**Coal Combustion Residue Impoundment  
Round 9 - Dam Assessment Report**

*Plant Kraft*  
*CCR Impoundment Ash Dikes*  
*Georgia Power*  
**Port Wentworth, Georgia**

Dewberry & Davis, LLC  
Fairfax, Virginia

Under Contract Number: EP-09W001727  
**December 2011**

Figure 5.2.4-1: Groin Area in Northwest Corner of Embankment

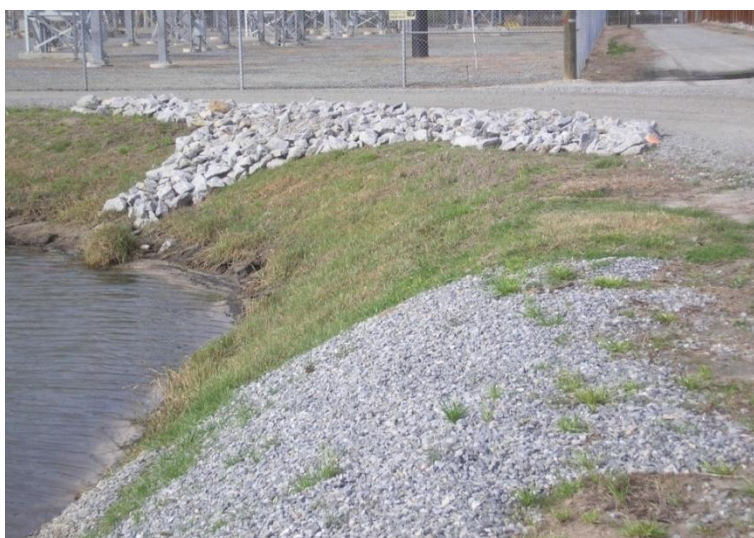
Erosion or uncontrolled seepage was not observed along embankment groins. Embankment groins on the north side of the CCR impoundment have had riprap added to protect against erosion caused by surface runoff across the embankment crest.

Figures 5.2.4-1 and 5.2.4-2 show the inside slope at the northwest and southeast groins, respectively.
